ZONING AMENDMENT,
PLANNED UNIT DEVELOPMENT &
SUBDIVISION STAFF REPORTS

Date: April 21, 2005

John F. Loupe

REQUEST Rezoning, Planned Unit Development, Subdivision

PLANNING COMMISSION VICINITY MAP - EXISTING ZONING

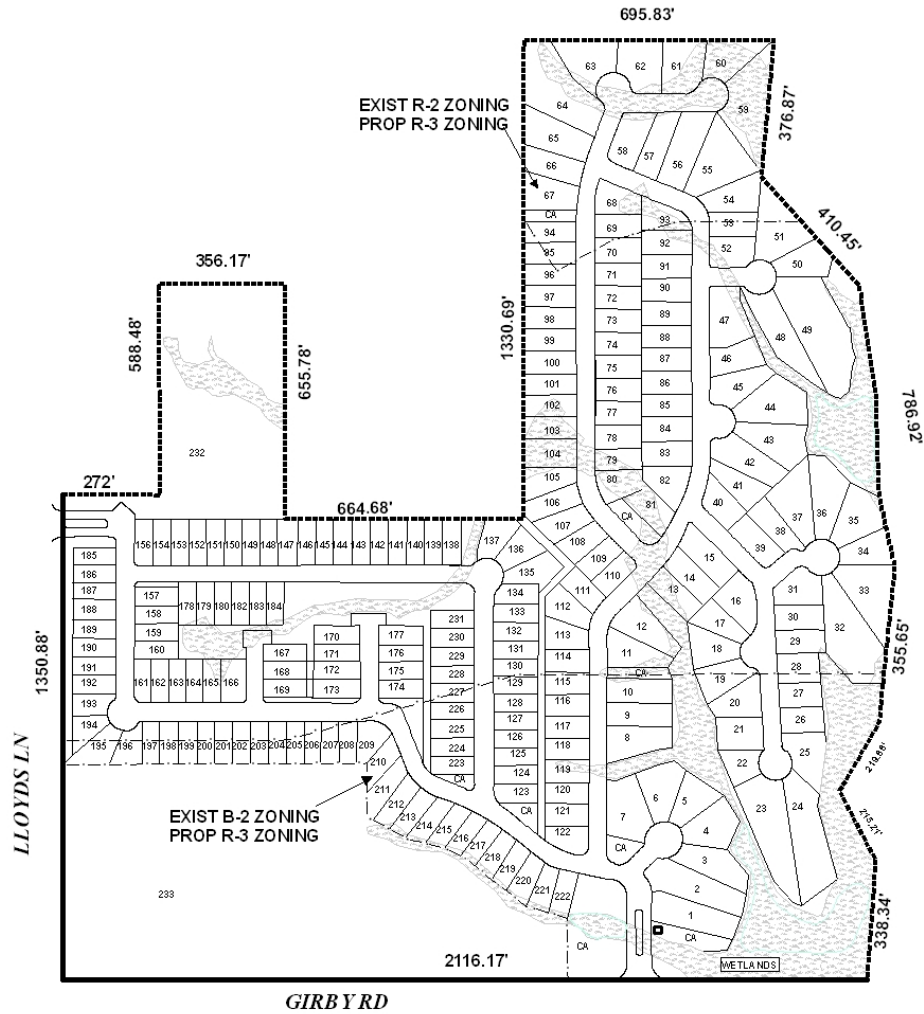
Section V.B.1 of the Subdivision Regulations state that "the street layout shall provide for the future projection into unsubdivided lands adjoining of a sufficient number...to provide convenient circulation." As illustrated on the Vicinity Map, the site adjoins multiple parcels to the West that are land locked, and the provision of two street stubs, one in the area between Lots 67 and 104 and a second street stub in the area between Lots 138-146, should be required. It should be noted that a street stub is not recommended to the East as the site borders a creek, and the Commission typically has not required street stubs to adjacent properties when the stub adjoins a waterway. Furthermore, street stubs were not required for the subdivision adjacent to the East.

SITE PLAN

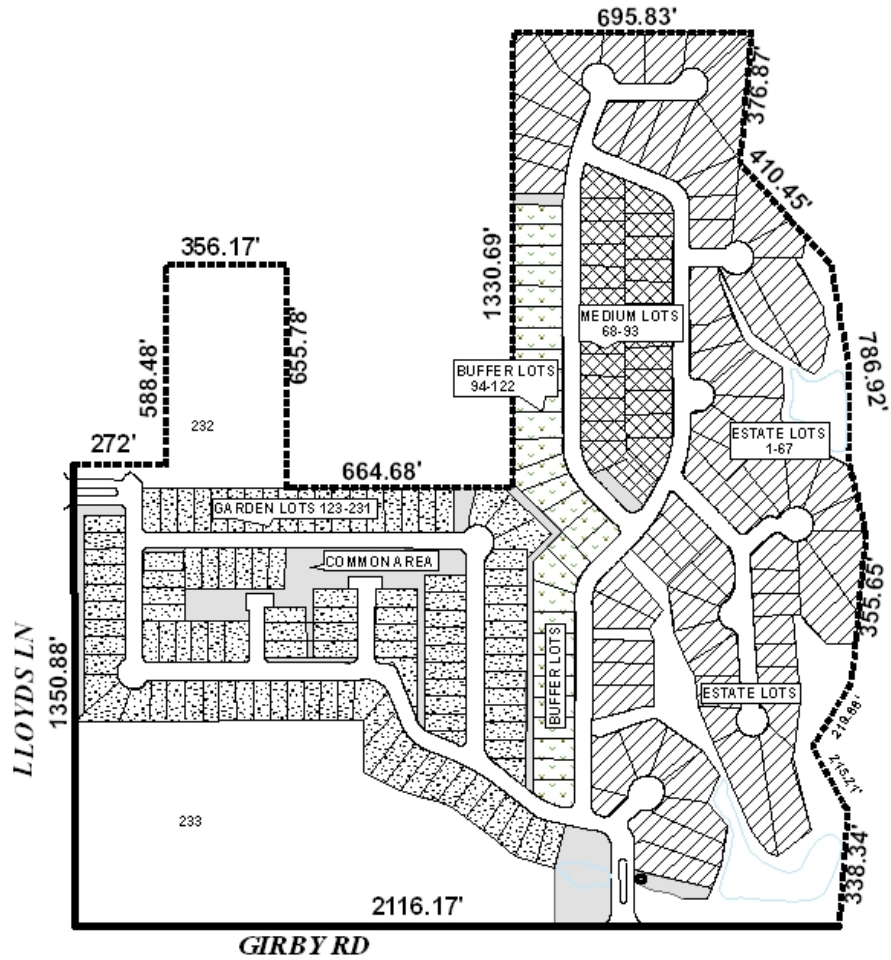
All commercial projects shall comply with the 2003 International Fire Code and Appendices B-G as adopted by the City of Mobile on July 6, 2004. All One- or Two-Family residential developments shall comply with Appendices B, C and D of the 2003 International Fire Code as adopted by the City of Mobile on July 6, 2004. Northwest portion of development should be provided with two means of access. This could be accomplished by providing a road where lots 107 and 136 are located.

The PUD is required to allow the reduced lot widths, lot sizes, and setbacks. The narrowest lots are the garden homes (Lots 123-222), and the smallest garden home lots are 50 x 120, which in terms of width and area are typical for residential PUDs. The overall site area in a PUD is calculated toward density requirements, and in a R-2 district, the overall site will provide adequate area for the number of homes proposed.

The proposed front setbacks vary from 15-feet to 25-feet, and again are typical for residential PUDs; however, the proposed sideyard setbacks for the garden homes are three-feet, two-inches. In approving residential PUDs, even for garden homes, the Commission has typically recommended an eight-foot minimum separation between structures; in this case, that would necessitate a minimum setback of four-feet from the side property lines.

The site adjoins a creek and as such the area may be considered environmentally sensitive; thus the approval of all applicable federal, state and local agencies would be required. Additionally, there are wetlands on the site, some of which encroach into the lots; and while reduced lot widths and sizes are allowed, the applicant should submit documentation prior to the recording of the final plat, which illustrates that there is adequate buildable area (6,000 square feet based on the minimum garden home lots) for those lots containing wetlands.

Planned Unit Development: Based upon the preceding, this application is recommended for approval subject to the following conditions: 1) full compliance with the Traffic Engineering Comments (driveway number, size, location and design to be approved by Traffic Engineering and conform to AASHTO standards, traffic calming measures should be included in development); 2) the provision of street stubs to the landlocked parcels to the West in the vicinity of Lots 67-104 and Lots 138-146; 3) that the applicant obtain all necessary federal, state and local permits; 4) completion of the rezoning process (to R-2) for the entire site; and 5) full compliance with all municipal codes and ordinances.

Subdivision: With a waiver of Section V.D.2., the plat will meet the minimum requirements of the Subdivision Regulations and is recommended for Tentative Approval subject to the following conditions: 1) full compliance with the Traffic Engineering Comments (driveway number, size, location and design to be approved by Traffic Engineering and conform to AASHTO standards, traffic calming measures should be included in development); 2) the provision of street stubs to the landlocked parcels to the West in the vicinity of Lots 67-104 and Lots 138-146; 3) that the applicant obtain all necessary federal, state and local permits; 4) completion of the rezoning process (to R-2) for the entire site; and 5) full compliance with all municipal codes and ordinances.
